CITY OF NAPERVILLE
PLAN REVIEW STATUS AND RESUBMITTAL INSTRUCTIONS

Project Name: 557 S Washington Street
Project Address: 557 S Washington Street
Project Number: DEV-0094-2025
Plan Set Name: Plat of Subdivision
Submittal Number: 2

Plan Review Status:
REQUIRES RESUBMITTAL

Face of Sign View Point Heading North and South on Washington St (Back to Back)

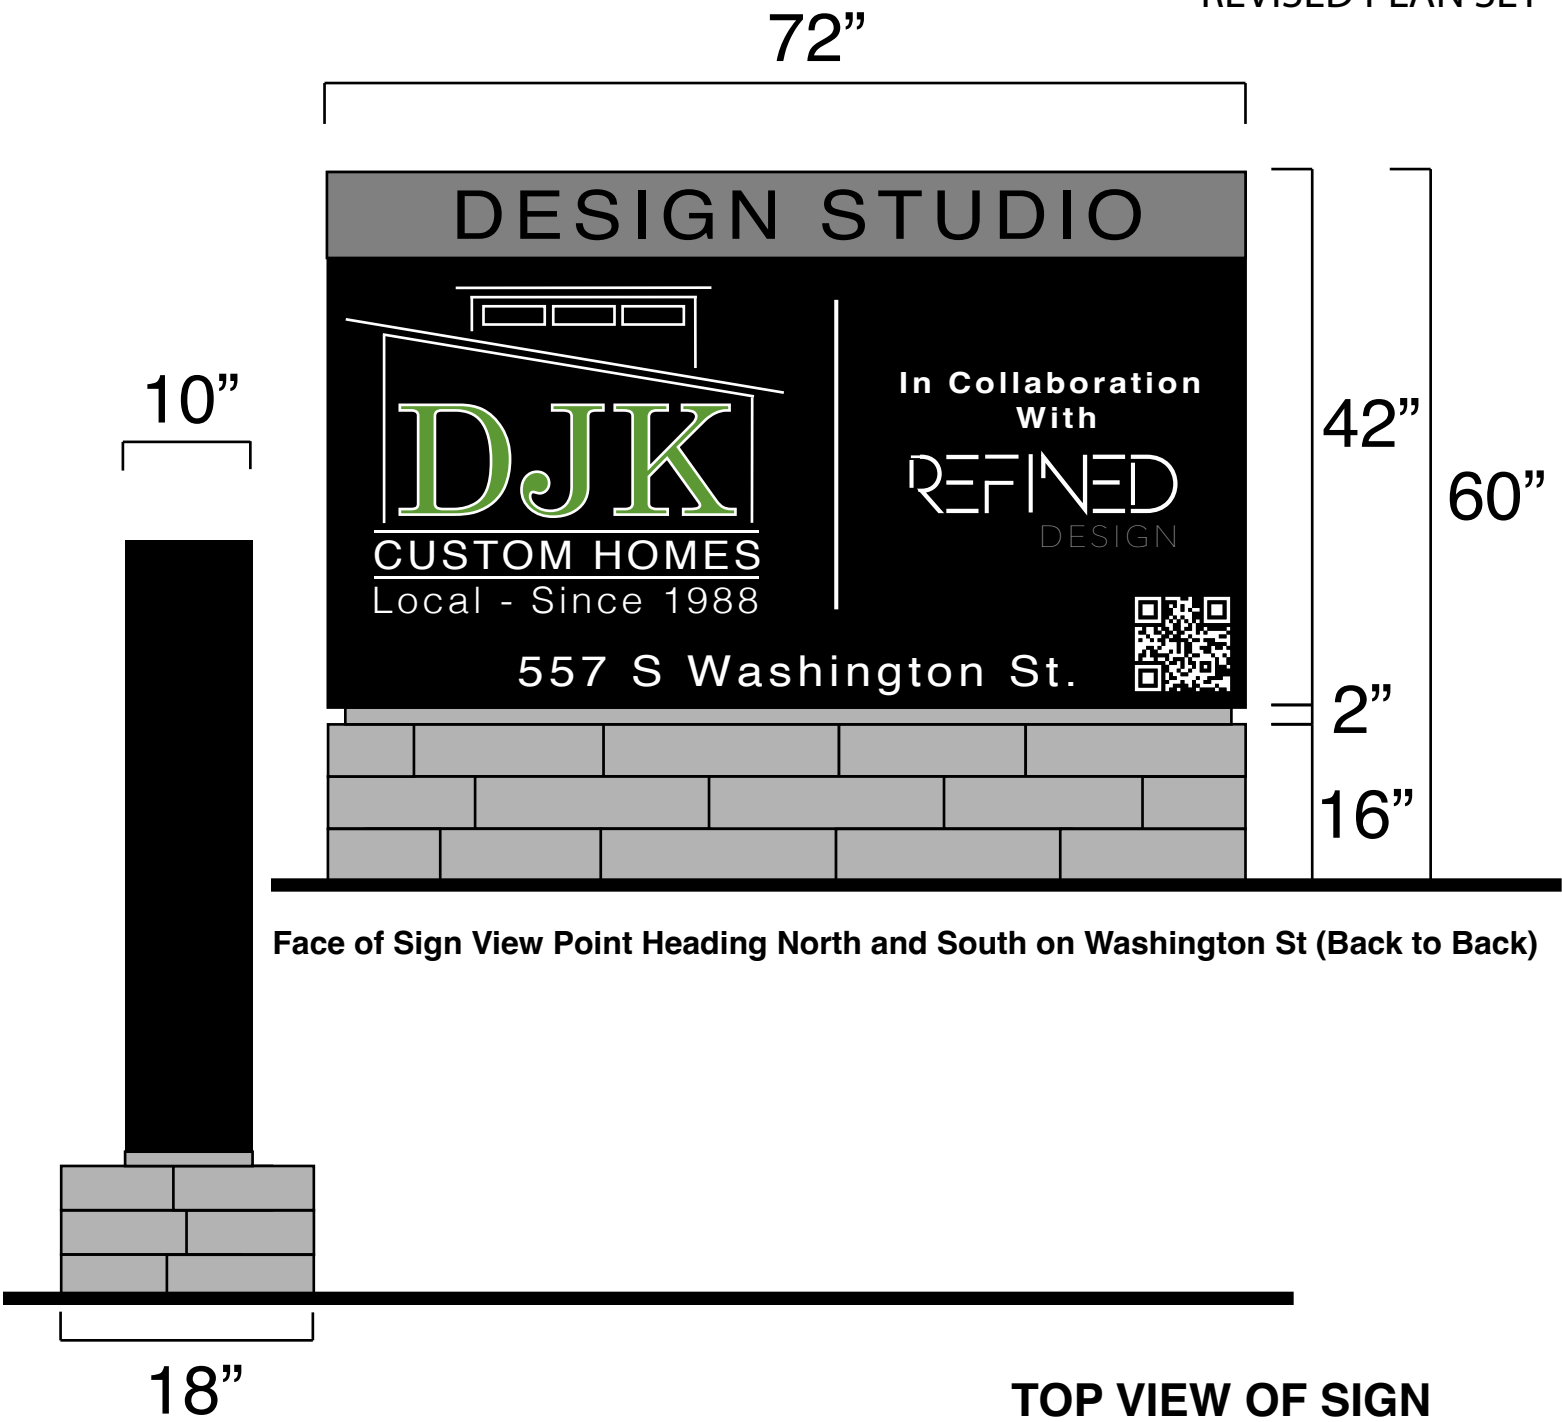
This signage is not permitted. Please remove.

The signage on the side view has been removed. Please reference Revised Plan Set

Side View of Sign Facing Washington

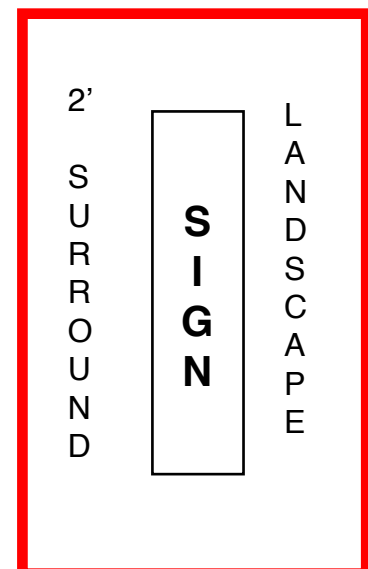
Per your response letter, the ground sign and the wall sign will not be internally lit, and will maintain the required setback along Washington.

No sign variances are anticipated; however, please be advised that sign permits will need to be obtained.

Confirmed the ground / wall sign will not be internally lit.
Confirmed will maintain required setbacks.
Confirmed no sign variances anticipated.
